# UNITED STATES PATENT AND TRADEMARK OFFICE

APPLICATION NO.	FILING DATE	FIRST NAMED INVENTOR	ATTORNEY DOCKET NO.	CONFIRMATION NO.
10/029,071	12/21/2001	Takeshi Yagi	1113-017/MMM	5313
	7590	03/30/2005	EXAMINER	
Ipsolon LLP 805 SW Broadway #2740 Portland, OR 97205			KIM, YOUNG J	
			ART UNIT	PAPER NUMBER
			1637

## **DETAILED ACTION**

Fig. 1

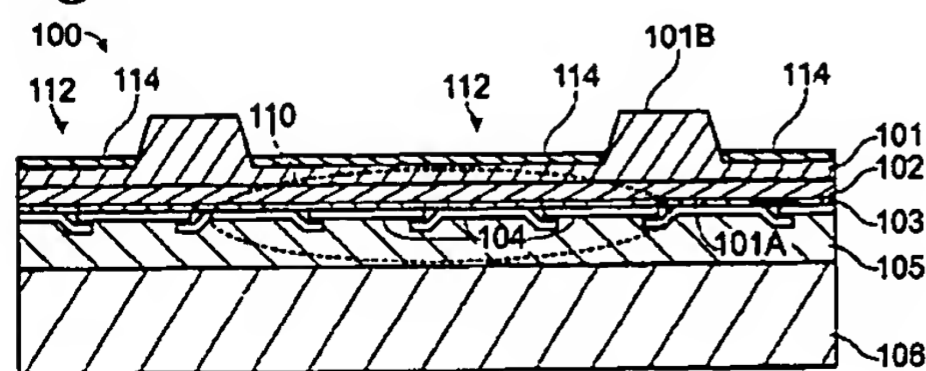
Claims 3 and 4 have been amended to include the limitation drawn to the semiconductor substrate having a thickness of 10 to 20  $\mu\text{m}$ , the thickness of which is measured from the organic molecules probe disposition region to the photoelectric converter, thus the distance between the two elements.

Figure 1 describing the claimed device is shown as below:

Section [0040] disclose that thickness "d1" is measured from surface "101B" to the bottoms of of the recesses "112", wherein the bottoms of the recesses "112" is disclosed being organic molecule

probe disposition region for fixing organic molecule probes (e.g., the DNA probes).

Section [0038] discloses that pixels “110” each have a photoelectric converter.

Thus, while the specification contains a proper written description for the claimed thickness when measured between the surface “101B” to the probe disposition region “112,” does not have written description support for the instant limitation, wherein the thickness is measured between probe disposition region “112” and the photoelectric converter “110”. As no support for this limitation could be found in the instant specification, and since claims as originally filed did not contain support for this limitation, the claim amendment contains New Matter.
